Technical Service Bulletin

SkyView Display Circuit Board Replacement

February 11, 2013

Figure 1 - Screenshot showing Hardware Group

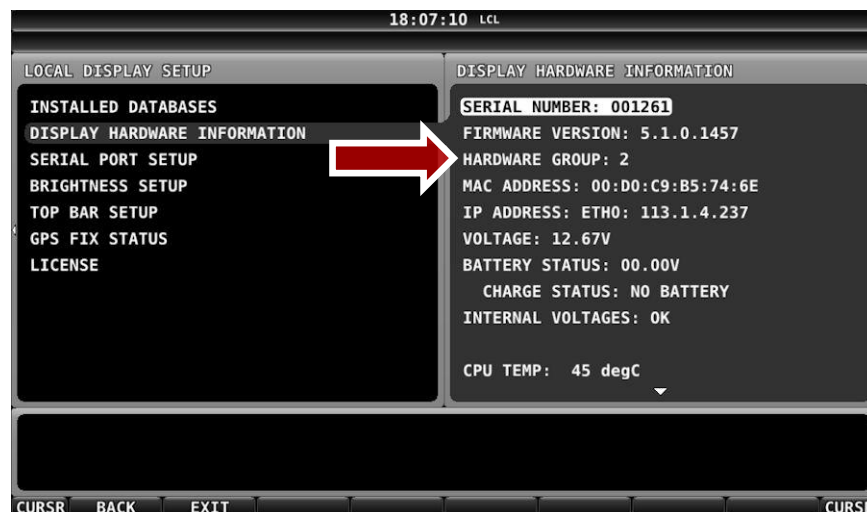
SV-D700 and SV-D1000 equipment that fall within **Hardware Group 2** are affected and should be returned to Dynon for repair. The displays in hardware group 2 were shipped from approximately mid-2010 to mid-2011, however, these dates are not authoritative. SkyView displays have the ability to report whether they are in the affected group.

Use the following process to verify which hardware group a display is in:

1. Turn on the SkyView Display.
2. Load version 5.1 firmware per the instructions in Section 3 of the SkyView Installation Guide.
3. Open the Setup Menu by pressing and holding buttons seven and eight.
4. Open the Local Display Setup Page
5. Open the Display Hardware Information Page
6. The Hardware Group information is displayed under the serial number and firmware version as shown in Figure 1.
7. It takes approximately 1 minute for SkyView to report a non-zero group number. If the Hardware Group number is zero, wait until it changes to either 1 or 2.
